# UNITED STATES PATENT AND TRADEMARK OFFICE

APPLICATION NO.	FILING DATE	FIRST NAMED INVENTOR	ATTORNEY DOCKET NO.	CONFIRMATION NO.
10/698,455	11/03/2003	Chin-Ku Chuang	CHUA3042/EM	3481
23364	7590	12/12/2005		EXAMINER
BACON & THOMAS, PLLC				MURALIDAR, RICHARD V
625 SLATERS LANE				
FOURTH FLOOR			ART UNIT	PAPER NUMBER
ALEXANDRIA, VA 22314				2838

<b>Office Action Summary</b>	<b>Application No.</b>	<b>Applicant(s)</b>
	10/698,455	CHUANG ET AL.
	Examiner Richard V. Muralidhar	Art Unit 2838

*Fig. 17*

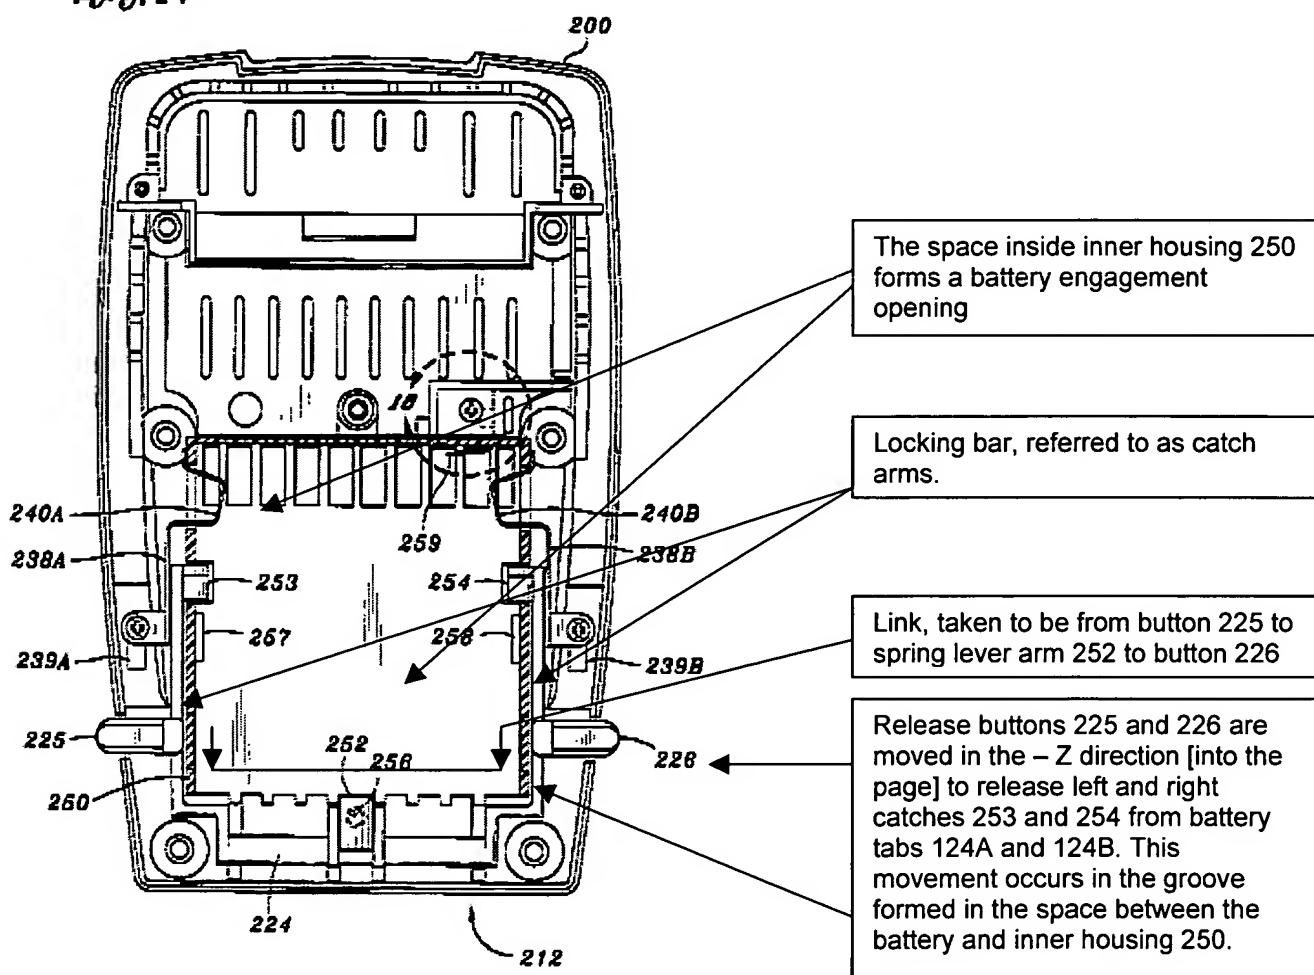
With respect to Claim 1, Small teaches a battery engagement structure used in a portable battery charging module and adapted to engage a battery pack for charging by said portable battery charging module [col. 1 lines 7-9], the battery engagement structure comprising: a housing [Fig. 17 housing 250], said housing comprising a bottom panel, a first side panel, and a second side panel [col. 12 lines 25-27 incorporates these components into a top half case 204 and a bottom half case 206], wherein said first side panel having an inner face, said second side panel abutted against one end of said first side panel [description inherent to this housing], a battery engagement opening [Fig. 17 reproduced below shows an inner space inside inner housing 250 that is an engagement opening] disposed at said first side panel, a sliding groove disposed at said first side panel in parallel to said inner face of said first side panel [in Fig. 17 reproduced

below, left and right catches 253 and 254 are connected to catch arms which move in a sliding manner in the groove formed by the space between the battery charger and the charger housing] a button hole disposed at said second side panel [Fig. 17 below shows finger releases 225 and 226 protrude though openings in the charger housing], and a pivot holder upwardly extended from said bottom panel adjacent to the connection area between said first side panel and said second side panel [in Fig. 17 below, spring lever arm 252 is pivotally balanced on spring 256, which indicates a means of holding the pivot in place, specifically located under spring lever arm 252] a button mounted in said button hole [Fig. 17 below shows buttons 225 and 226 mounted through the side openings] ; an operation mechanism, said operation mechanism comprising a locking bar, and a link [Fig. 17 below shows an operation mechanism consisting of catch arms and a spring lever arm link 252], wherein said locking bar mounted in said sliding groove [the sliding groove is formed by the space between the charger and housing as indicated in Fig. 17 below] and movable along said sliding groove in and out of said battery engagement opening [the catch arms with left and right catches 253 and 254 slide in and out of the indicated battery engagement opening as indicated in Fig. 17 below], said locking bar having a front end insertable into said battery engagement opening [left and right catches 253 and 254], said link [taken to be from button 225 across spring lever arm 252 to button 226] having a first end [at the point of connection to button 225], a second end [at the point of connection to button 226], and a middle part [at the center where spring 256 is located], said first end coupled to said locking bar, said second end stopped at said button, and said middle part pivoted to said pivot holder [spring 256 denotes the middle of lever arm 252 and is pivoted at that point, and

thus incorporates a means of holding the pivot in place]; and spring [Fig. 17 below shows spring 256] means adapted to impart a prestress to said locking bar to force the front end of said locking bar inserted into said battery engagement opening [spring 256 forces the entire latching structure to move upwards and releaseably engage the battery recess].

4. With respect to Claim 5, Small discloses the battery engagement structure as claimed in claim 1, wherein the middle part of said link [Fig. 17 shows an operation mechanism consisting of catch arms and a spring lever arm link 252] has a pivot hole pivotally connected to the pivot holder of said housing by a screw [spring 256 denotes the middle of lever arm 252. It is pivoted at that point, and thus incorporates a means of holding the pivot in place, utilizing any common means such as a screw].
